Grant of a patent is requested on the basis of new claims 1 to 4, original description pages 2, 6, 7 and 9, amended description pages 1, 4, 5, 8 and 10 to 12 as filed with our letter of November 30, 2006, new description page 3, original pages 1/4, 3/4 and 4/4 of the drawings and new page 2/4 of the drawings.

**CLAIMS**

FIG. 2

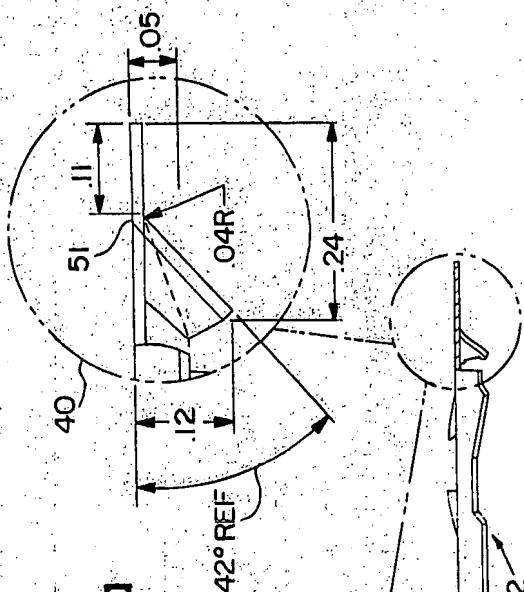
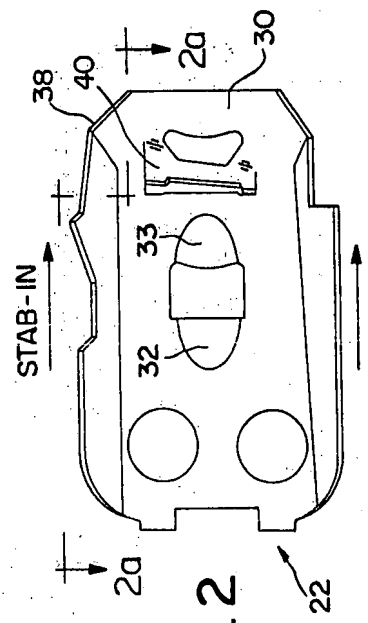
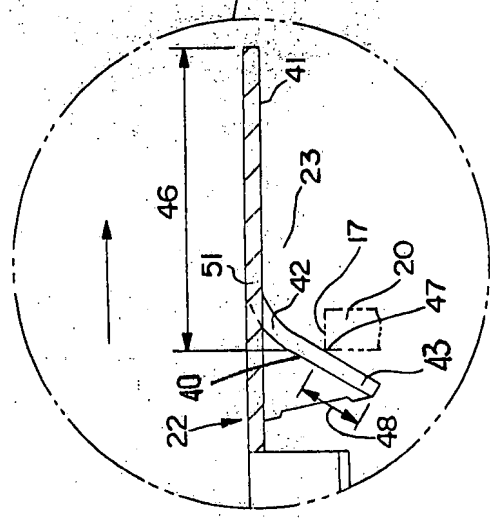
- new claims 1 to 4
- amended description page 3
- amended page 2/4 of the drawings
